RE: Docket ID No. EPA-HQ-SFUND-2015-0139
NPL Listing Proposal for Anaconda Aluminum Co. Columbia Falls Reduction Plant: Comments of Atlantic Richfield Company

TECHNICAL REPORT

SUBJECT: Review of the Columbia Falls Aluminum Company, LLC (CFAC), HRS Documentation Record

Cyanide Concentrations (Oct 2013) in Surface Water and Ground Water
Columbia Falls Aluminum Company, LLC

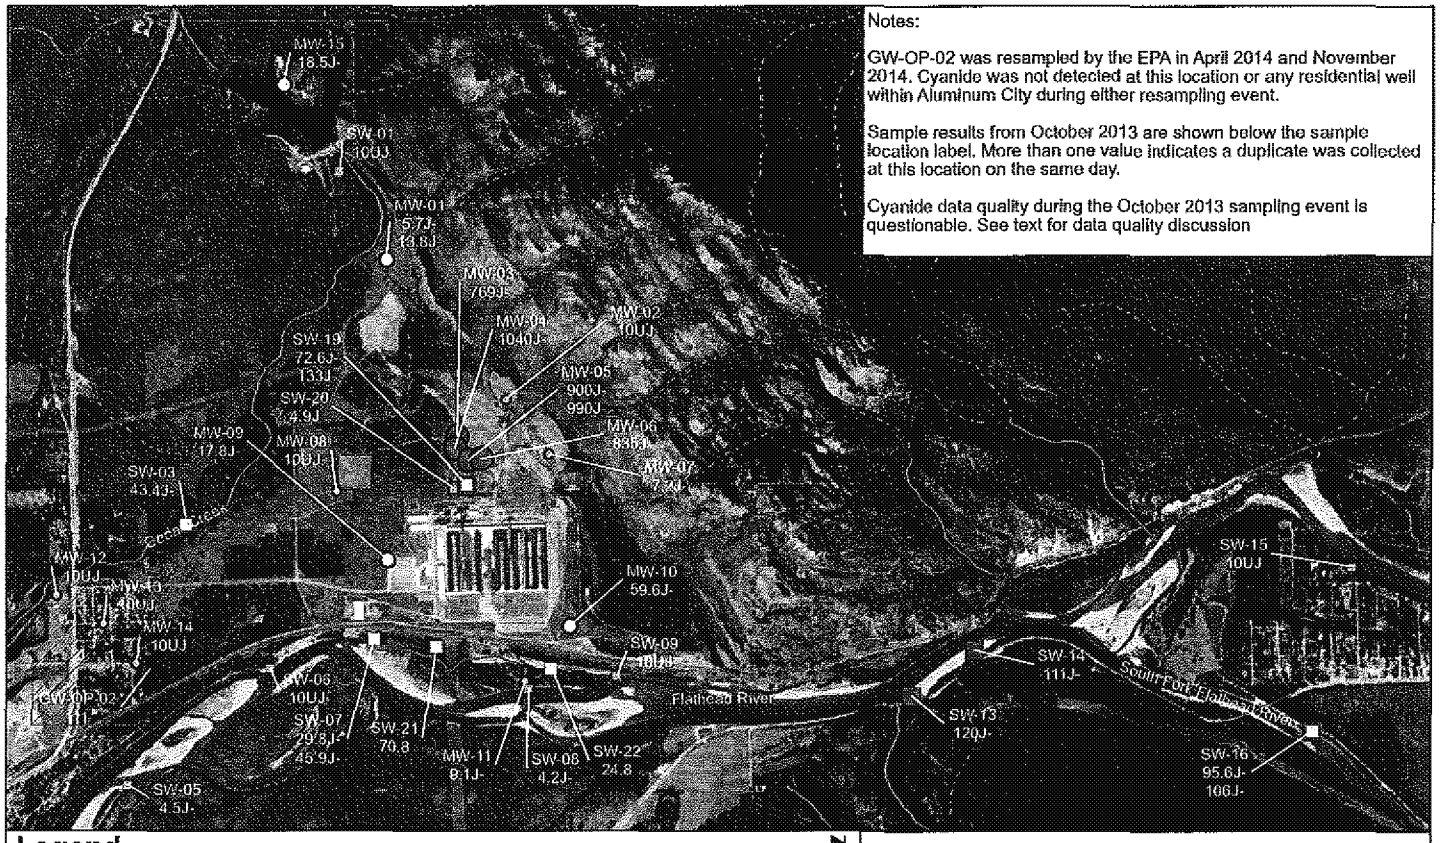
As shown on attached Figure 1, Cyanide was also detected in the background samples in the Flathead River (SW-13 at 120 ug/L, SW-14 at 111 ug/L, and SW-16 at 96-106 ug/L) upstream of the Site at concentrations significantly greater than Flathead River samples below the Site (SW-06 at <10 ug/L and SW-05 at 4.5 ug/L). Cyanide was also detected in the background groundwater upgradient of the Site above Cedar Creek Reservoir (MW-01 at 18.5 ug/L). If cyanide was migrating from the West Landfill through the alluvial aquifer, it is reasonable to expect intermediate cyanide concentrations along the groundwater flow path and in adjacent monitoring wells to the residential well where cyanide was detected; yet, this was not the case based on the available analytical results. The monitoring wells along the potential groundwater flow paths (MW-08 and MW-09) from the West Landfill had cyanide concentrations less than the background well (MW-15) and the monitoring wells adjacent to the residential well did not have detectable concentrations of cyanide.

Considering that the cyanide concentration observed in well CF-GW-OP-02 was not confirmed with resampling (or even detected) in subsequent sampling rounds, combined with the fact that surrounding wells have cyanide concentrations below detection or below background concentration, further supported by the fact that the cyanide concentrations upgradient of the site in the Flathead River are greater than the cyanide concentrations downstream of the site, it is highly probable that the initial cyanide result at CF-GW-OP-02 was an analytical error and not an indication of actual groundwater migration between the landfill and the Aluminum City well.

GW-OP-02 was resampled by the EPA in April 2014 and November 2014. Cyanide was not detected at this location or any residential well within Aluminum City during either resampling event.

Cyanide data quality during the October 2013 sampling event is questionable. See text for data quality discussion

Based on the information described above, the "Targets" component score on the Groundwater Migration Pathway Scoresheet should be revised to reflect the cyanide results from the follow up sampling rather than the initial sample.

Manganese Concentrations (Oct 2013) in Surface Water and Ground Water
Columbia Falls Aluminum Company, LLC

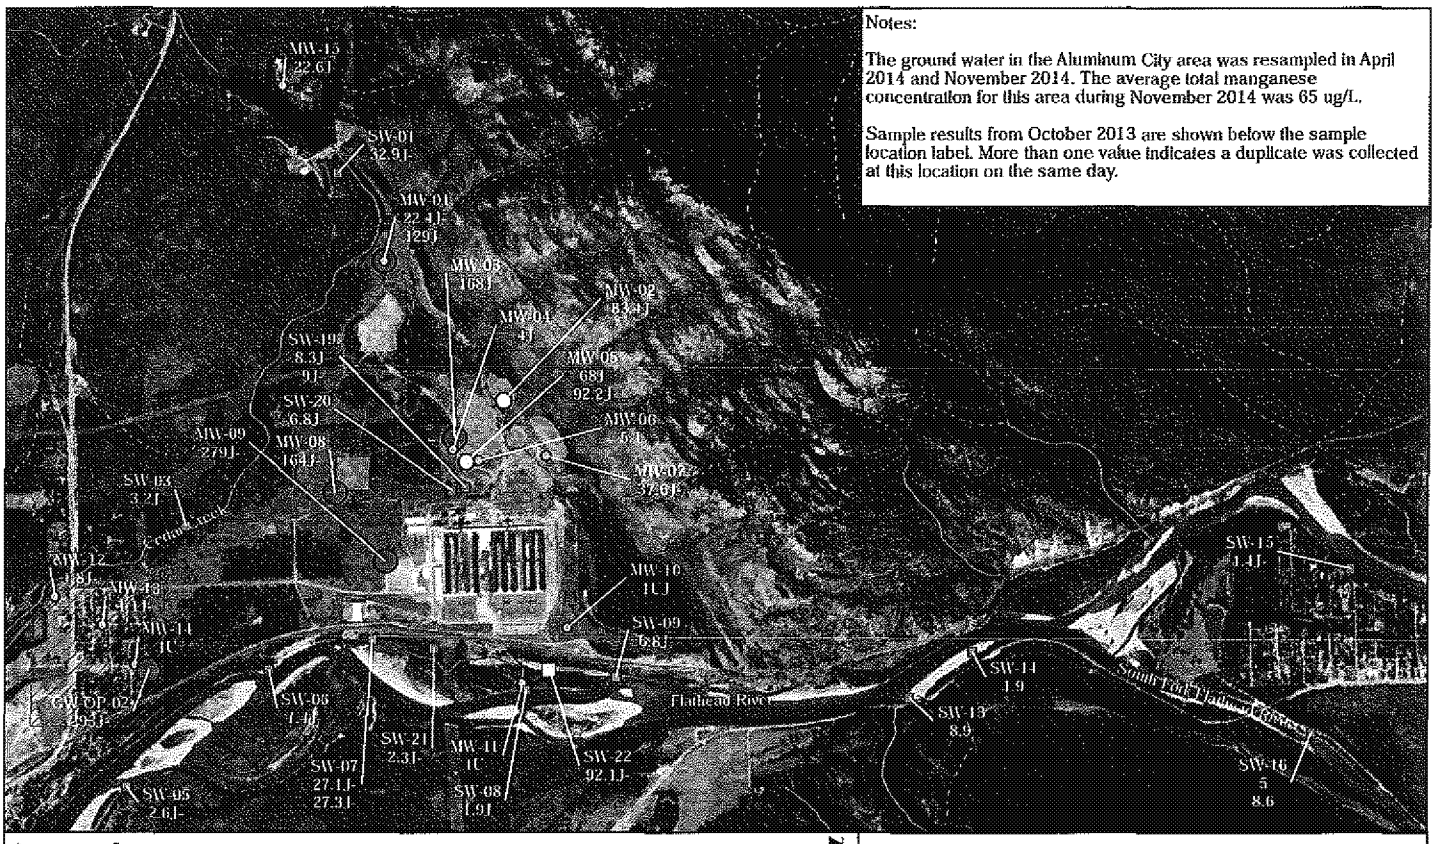
Additionally, as shown on attached Figure 2, the total manganese concentration at this location (CF-SW-07) was less than the Cedar Creek background sample (SW-01 @ 32.9 ug/L) and less than the average groundwater background concentration upgradient from the Site (CF-GW-MW-01 @ 75.7 ug/L). It is reasonable to assume that the CF-SW-07 sample is comprised of a significant amount of alluvial groundwater discharging to this backwatered area of the Flathead River and the results from CF-SW-07 should not only be compared to the Flathead River background samples, but also the alluvial groundwater background samples.

The ground water in the Aluminum City area was resampled in April 2014 and November 2014. The average total manganese concentration for this area during November 2014 was 65 ug/L.

Since the CF-SW-07 sample location is likely dominated by groundwater flowing from north to south across the Site, the score should be recalculated assuming background is represented by the Flathead River, Cedar Creek, and groundwater background concentrations. Additionally, a pathway specific toxicity value should be used during the recalculation of the score for this component.
